Determination 2013/038

The compliance of remedial work proposed for the skillion roofs of a house at 1134 Glenorchy/Paradise Road, RD1, Glenorchy

Figure 1: Roof construction (not to scale)

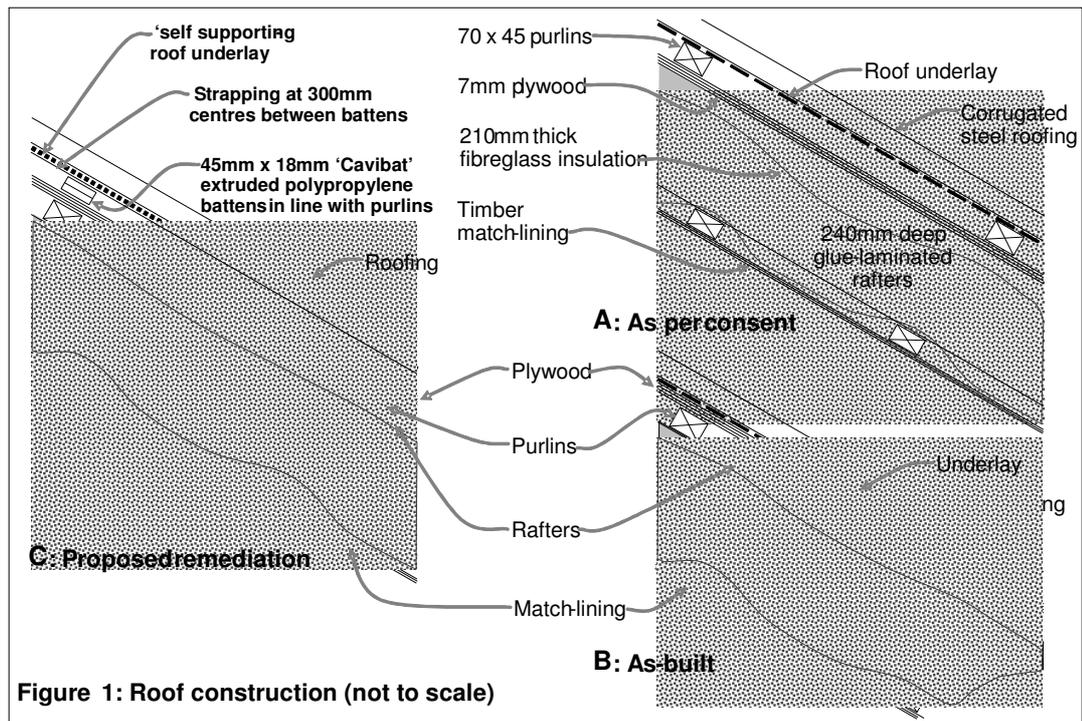
2.3.1 The roof as constructed varies from the consent drawings (refer Figure 1, which also shows the amendments proposed for the roof). The constructed roof varies from the details in the consent drawings in the following ways:

- Detail A: the consent drawings
 - The roof framing drawing calls for 7mm thick plywood ‘over all roof rafters’ (although plywood is not shown in larger scale roof details).
 - Manufacturer’s information for the specified fibreglass insulation provides a ‘nominal stabilised thickness’ of 210mm, which should allow an air gap of about 30mm between the 240mm deep rafters.
 - Heavy weight self-supporting roofing underlay over 70mm x 45mm purlins at 900mm centres provides an air gap between the purlins.
- Detail B: the constructed detail
 - Plywood is fixed to the roof purlins.
 - Blocking is added above the rafters between the purlins, limiting cross-ventilation beneath the plywood.
 - Fibreglass insulation generally fills the cavity beneath the roof purlins.
 - Roof underlay is laid directly over the plywood, with no underlying air gap beneath the underlay.

2.4.1 The proposed roof detail is shown in Detail C; the work adds

- proprietary polypropylene battens, with an open ventilated structure, fixed over the plywood into the roof purlins
- new self-supporting roof underlay laid directly over the battens, with strapping at 300mm centres to prevent sag reducing the underlying air gap
- fixings to existing roof cladding to be 20mm longer to accommodate battens
- new ventilated ridge cappings installed to both gables
- new soffit vents installed to ensure ventilation.

5.1.1 When considering the likely causes of the moisture damage to this skillion roof and the limited areas visibly affected to date, I make the following observations:

- Because the underlay is laid directly onto plywood, any condensation absorbed into the roof underlay is limited to dissipating only via the roof corrugations.

- Upper roof levels have no ventilation, as the existing roof underlay is wrapped over the ridge lining and the ridge capping is not ventilated.
- In regard to the restriction of visible water staining to one location on the match lining, I note that

- Any other damage within the roof structure should be apparent during the specified preparatory inspections, and the specification also calls for any damaged materials to be replaced.
- Products and materials specified for the work appear appropriate for the purposes, and the specification calls for work to comply with the roofing code of practice⁵ and with product manufacturers' instructions.
- The specified roof underlay is a self-supporting absorbent underlay capable of spanning the 900mm maximum between the new battens, with additional support tape at 300mm centres to ensure that the underlying 18mm air gap remains unobstructed.

- The specification calls for the installation of ridge and soffit vents and the specified battens have an open honeycomb structure. This combination should provide sufficient free air flow beneath the roof underlay to allow condensation moisture collected by the underlay to disperse to the outside.
- In regard to the reinstated roofing, the specification also calls for any roofing and flashings damaged during the remedial work to be replaced.

5.3.2 In the case of the roof remediation proposed for this house, the building surveyor's report and the other evidence have provided grounds for me to be satisfied that the proposed roof repairs will comply with Clauses E2, E3 and B2 of the Building Code.

6.1 In accordance with section 188 of the Building Act 2004, I hereby determine that the proposed roof repairs comply with Clause E2, Clause E3 and Clause B2 of the Building Code.
